COUNCIL ASSESSMENT REPORT

Panel Reference	2016SCL002
DA Number	DA502/2016/1
LGA	Woollahra
Proposed Development	The consolidation of 2 allotments, alterations and additions to the existing heritage listed dwelling-house at 6 Queens Ave, the demolition of an existing dwelling-house at 8 Queens Ave and the construction of a new dwelling to form a horizontally attached (at lower ground floor level) dual occupancy development, swimming pool, landscaping & earthworks
Street Address	6 & 8 Queens Avenue Vaucluse
Applicant/Owner	Mr J & Ms Y Lin
Date of DA lodgement	18/11/2016
Number of Submissions	3
Recommendation	Conditional approval
Regional Development Criteria (Schedule 4A of the EP&A Act)	Cost of works in excess of \$20 million (\$22,093,500)
List of all relevant s79C(1)(a) matters	<ul style="list-style-type: none"> • SEPP (Building Sustainability Index: BASIX) 2004 • SEPP 55-Remediation of Land • SREP (Sydney Harbour Catchment) 2005 • Draft SEPP (Coastal Management) 2016 • Woollahra LEP 2014 • Woollahra DCP 2015 • Woollahra Section 94A Contributions Plan • Clause 92 of the EPA Regulation 2000

DEVELOPMENT APPLICATION ASSESSMENT REPORT

FILE No.	DA502/2016/1
ADDRESS	6 & 8 Queens Avenu

The diagram below indicates the 9.5m height plane. The sections of the building envelope and roof profile of the existing-house located above Council's 9.5m height plane are not proposed to be increased or altered from that as existing.

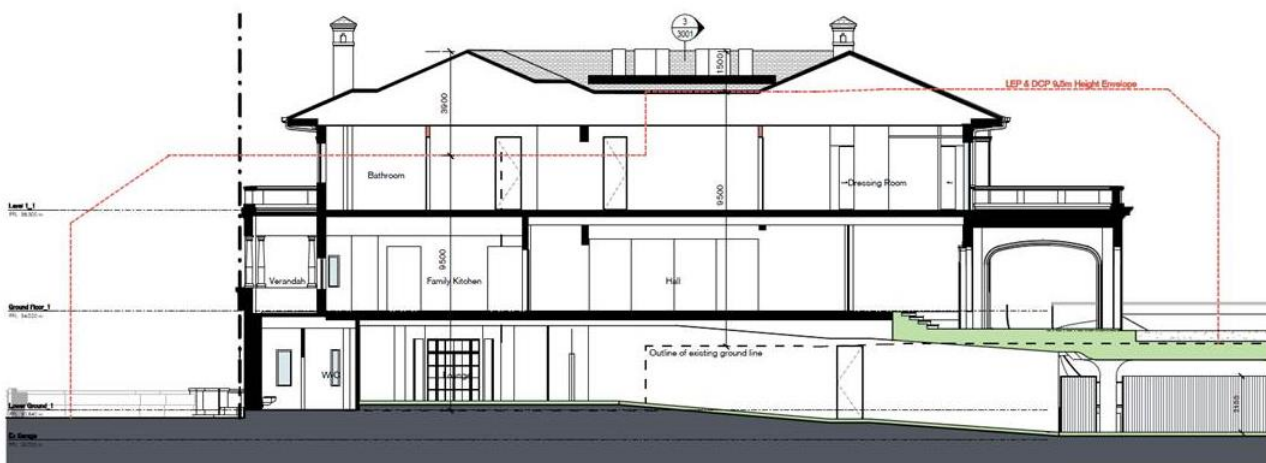
Part 4.3 limits development to a maximum height of 9.5m. The proposal involves a maximum height of 13.5m above existing ground level, a non-compliance of 4m (42%).

The non-compliant aspects of the proposal relate to replacement air-conditioning condensing units to the existing centrally located rooftop mechanical plant deck and internal and external alterations to the upper, southern section of the heritage listed dwelling-house at 6 Queens Avenue associated with the proposed conservation, restoration and adaption works. The subject non-compliant external alterations involve the replacement of existing windows and doors with new metal framed high performance glazing and the addition of a set of double doors to provide access to the western terrace from Bedroom 3 at Level 1.

The sections of the building envelope and roof profile of the existing-house located above Council's 9.5m height plane are not proposed to be increased or altered from that as existing.

The replacement of air-conditioning condensers to the existing centrally located rooftop mechanical plant deck will not be significantly visually discernible from external perspectives as the deck is surrounded by hipped roof forms on all four sides.

Existing view

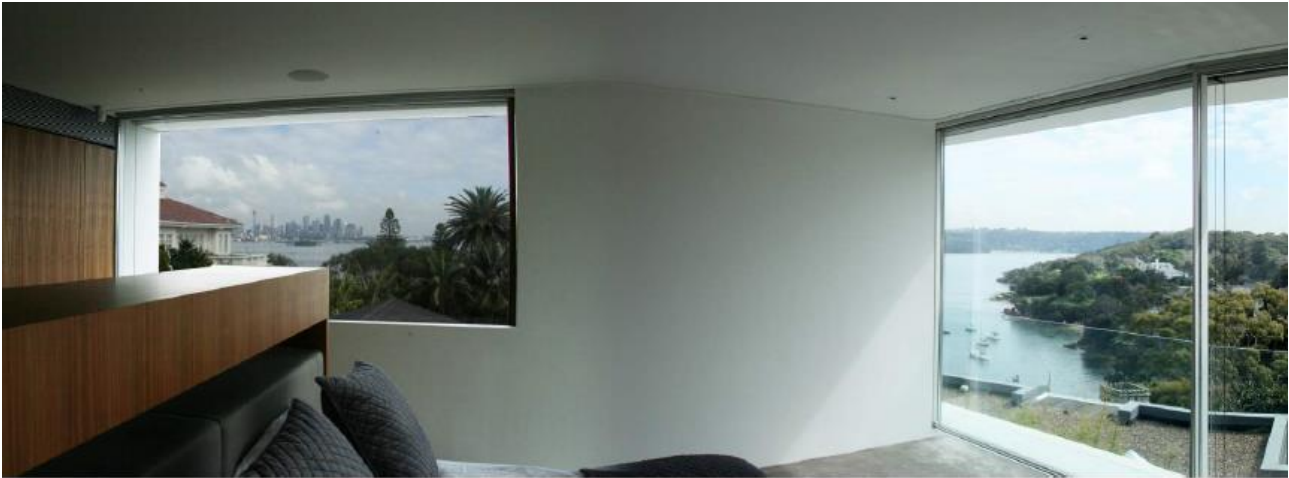
The images below are from the ground floor level rear terrace - standing position.

Proposed (green) and approved DA514/2011/4 (red outline)
